**CITY OF SACRAMENTO**

Permit No: 0504430

Site Address: 7421 POCKET RD SAC

Nature of Work: REMODEL BATHROOM

Old floor plan

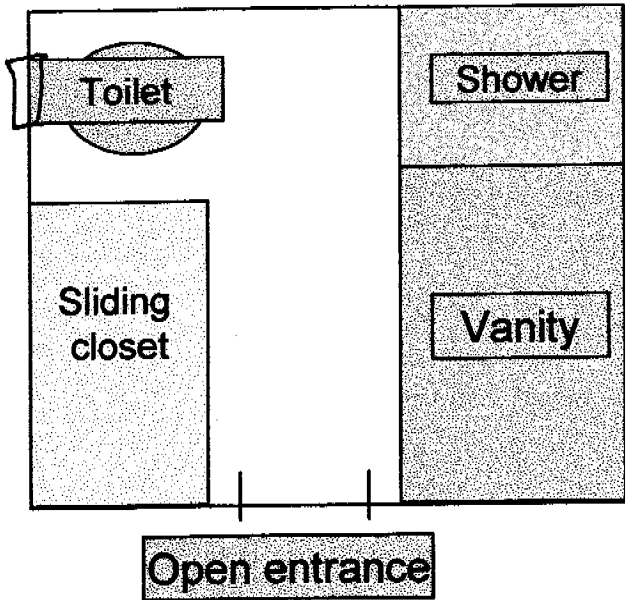
INSTALL ALL GFCI  
 PER NEC 210-8

THE APPROVAL OF ALL  
 PLUMBING / MECHANICAL /  
 ELECTRICAL  
 IS SUBJECT TO FILED INSPECTION

9x9 ALL DWELLING BRANCH  
 CIRCUITS PER NEC  
 ARTICLE 210

New floor plan

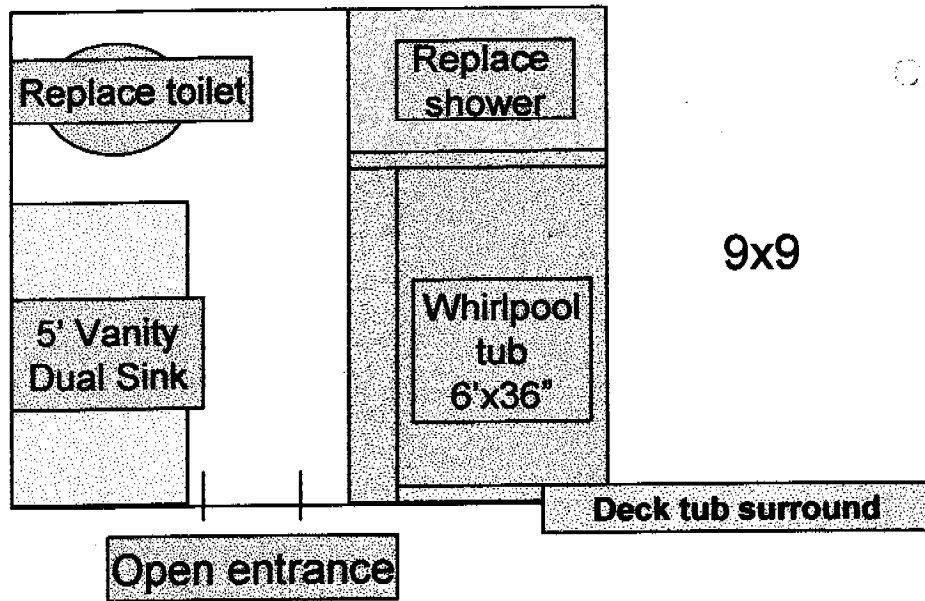
Thornton Bathroom Remodel  
 Retrofit / ADD Fixtures  
 NO STRUCTURAL
